RE: Comments on Froom Ranch Specific Plan Draft EIR

From: David Chipping: [REDACTED] Los Osos, CA 93402
(Prof. Emeritus, Geology: CalPoly, SLO)

Topo base map from 1900. The creek crossing of the main highway and railroad is essentially at the current freeway overpass. LOVR and Madonna Rd. are present, but LOVR dead ends short of the current overpass

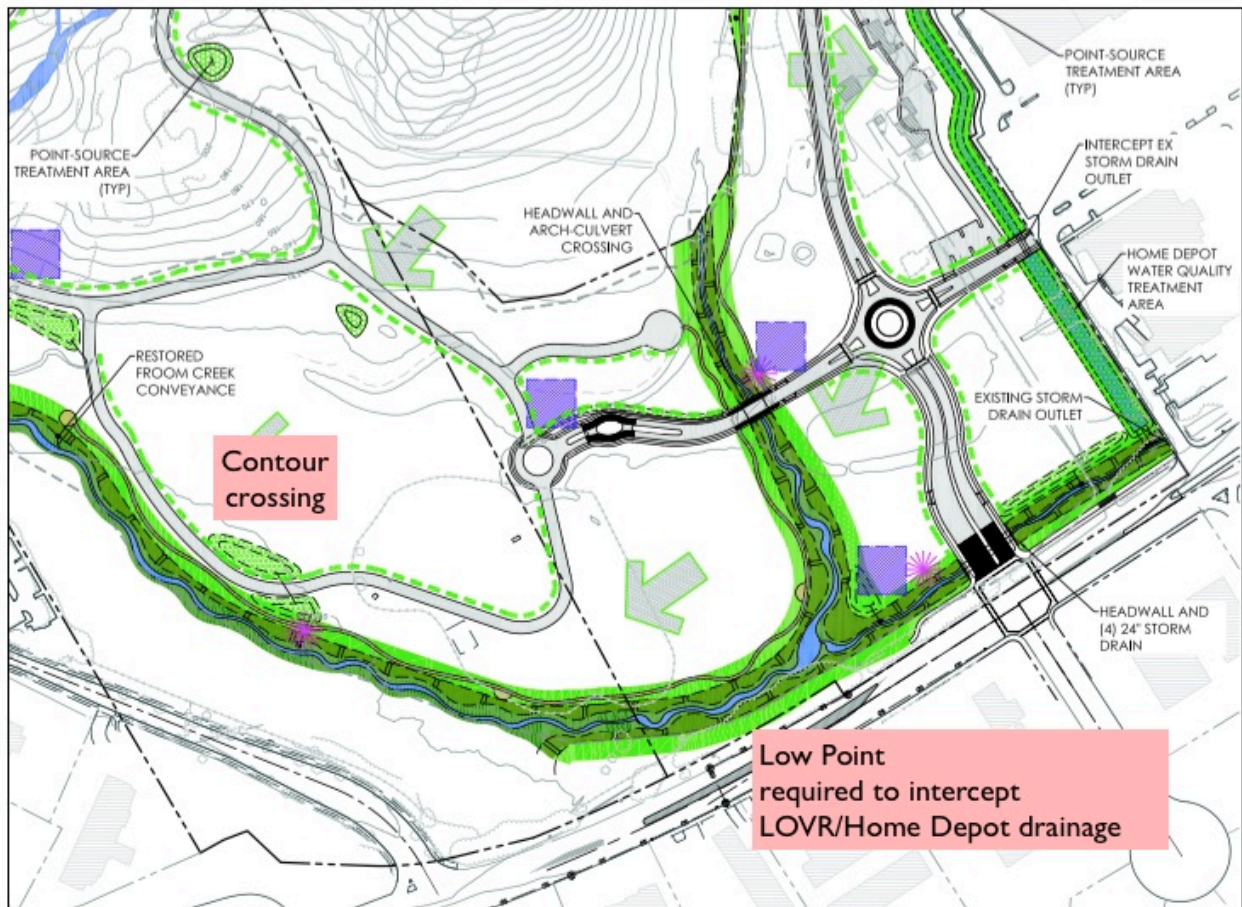
On page 13 (I-5) Appendix H states “*Development of the Specific Plan area will enhance and restore the historic Froom Creek corridor alignment and allow it to traverse future development areas.*” It is true that the original alignment joined the Laguna Lake close to the edge of what is now LOVR (topographic map from 1900). It then flowed through the currently lowest part of property and joined San Luis Creek. In no way did it turn southward and follow the current drainage along the eastern property line. Thus the creek realignment cannot be cited as a significant historic restoration. This is correctly noted in Section 1.4.

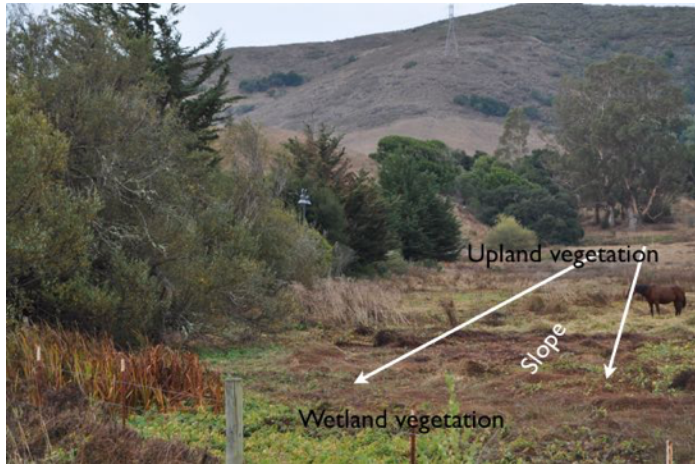
The following photograph shows the alluvial fan that is derived from the three small drainages at the southern end of the property, with the white arrows showing the slope direction of the fan surface. See also the contours on the picture above. The picture is taken

at the point where the proposed channel with turn to the northwest, with green wetland vegetation in the foreground.

Question: How will channel excavation affect subsurface water conditions in the jurisdictional wetlands adjacent to Calle Joaquin. Reference is given to pages. 228 and 230 of Appendix H, creek sections 2031 and 1757, which are shown cutting into the edge of the wetland by as much as 4 feet.
